UNITED STATES PATENT AND TRADEMARK OFFICE

APPLICATION NO.	FILING DATE	FIRST NAMED INVENTOR	ATTORNEY DOCKET NO.	CONFIRMATION NO.
10/771,991	02/03/2004	Marc Duarte	1948-4837	6281

Office Action Summary	Application No. 10/771,991	Applicant(s) DUARTE ET AL.	
	Examiner James W. Cranson	Art Unit 2875

DETAILED ACTION

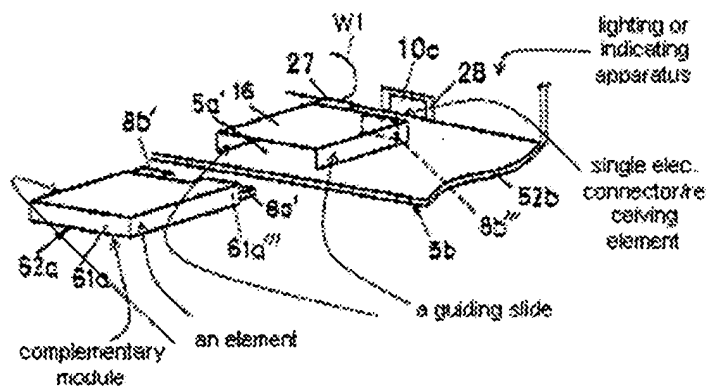
Claim 19, according to claim 4, wherein the complementary module and the lighting element are secured to each other by means of a spring for exerting pressure on a rear portion of the complementary module, whereby to maintain the electronic circuit board rooted in the aperture of the connector base. The examiner takes OFFICIAL NOTICE that it is well known in the Mechanical Arts to use a spring to exert pressure.

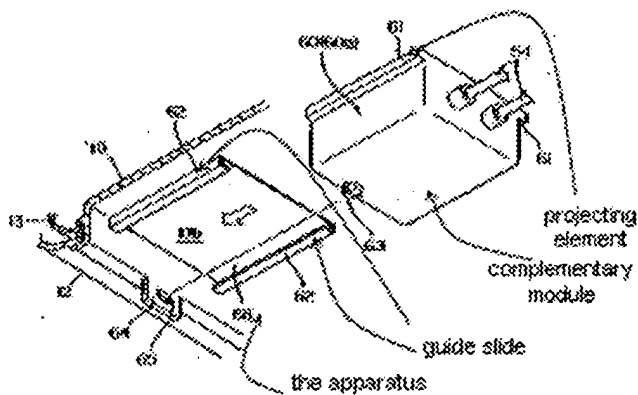
Regarding claim 26, Ueno et al. discloses a reflector (e.g., 3), a light source (e.g., 1), and a casing (e.g., 52a, 52b, 52e, 52f, 52h) which defines a set of faces (e.g., Figures 1, 4, 6-9, 15, 19,

20, 24), having side, lower and upper faces, wherein, the apparatus is adapted to be combined with at least one complementary module (e.g., a lighting device; 62a) with the aid of at least one pair ("left and right portions of the body"; Figure 18; 62c or 10 and 27 in Figure 22) of assembly element comprising a guiding slide (Figures 10-14, 21-23) and an element (shown & indicated in below drawing figure) being adapted to be complementary to at least one end of the slide associated with the element and to slide in the slide, each of the assembly elements of the pair of assembly elements being disposed either on the lighting or indicating apparatus (5a) or on the complementary module ("a lighting device"; 62a), each assembly element in one the pair being disposed in a different one of the components consisting of the lighting or indicating apparatus ("luminaire") and the complementary module (a lighting device; 62a), the module having a single electrical connector (8b'; Figures 10, 13, 14, 16 and 17), and the apparatus (luminaire) having a single receiving element (8b; Figures 10, 13, 14, 16 and 17) for the connector of the complementary module (lighting device; 62a).

Ueno et al. failed to disclose the details of a **projecting** element, where the element being inserted into one end of the slide.
